Oxford Flood Alliance (OFA) comments on revised Flood Risk Assessment dated November 2017

Submitted 29 November 2017

The Oxford Flood Alliance (OFA) maintains its objection to this planning application. We have reviewed the revised Flood Risk Assessment (dated November 2017) and have the following comments.

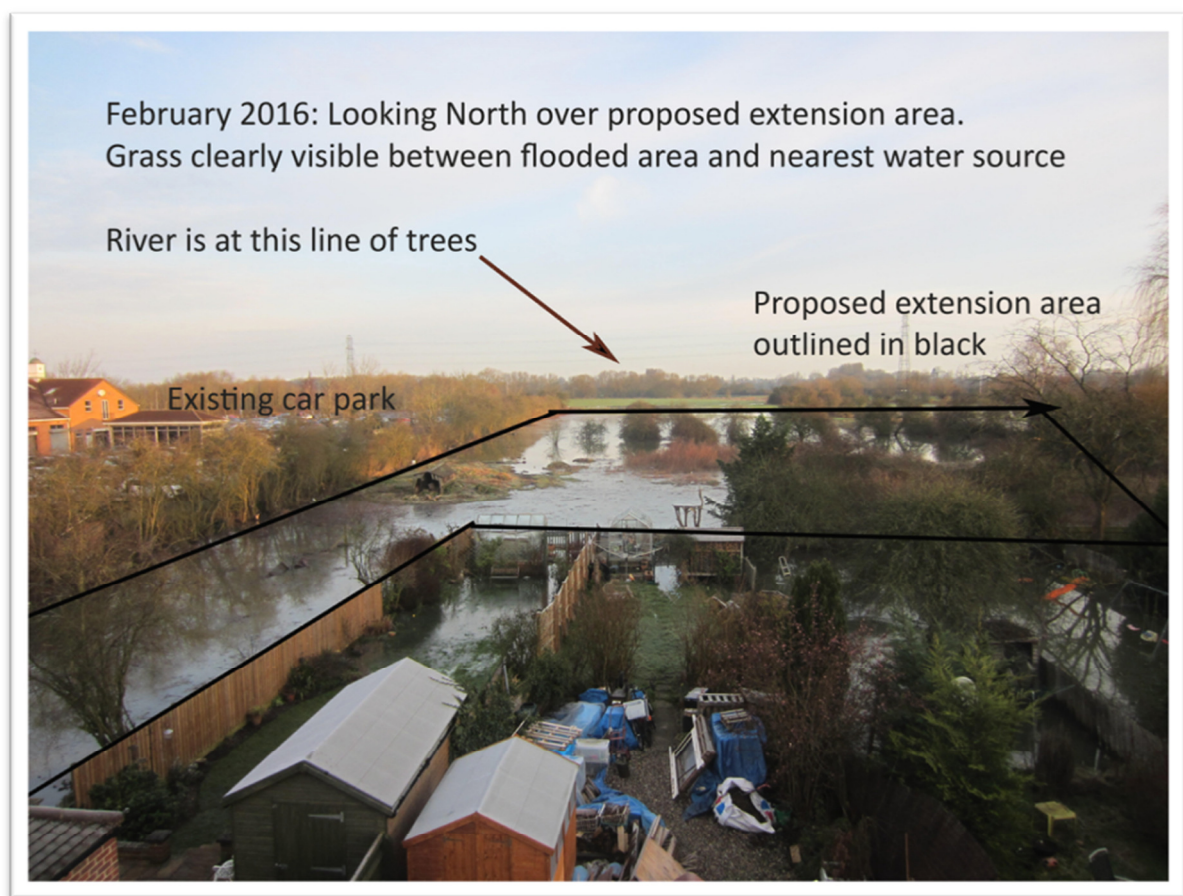
The photo shows groundwater flooding that is not due to fluvial flooding, although the Applicant alleges that groundwater flooding only occurs with fluvial flooding at this site. Local residents know that this field in particular remains flooded from groundwater for long periods. The photo also shows the extent of undulation in the site: some of the flooded areas are up to 1m deep, while other small patches are just above the floodwater.
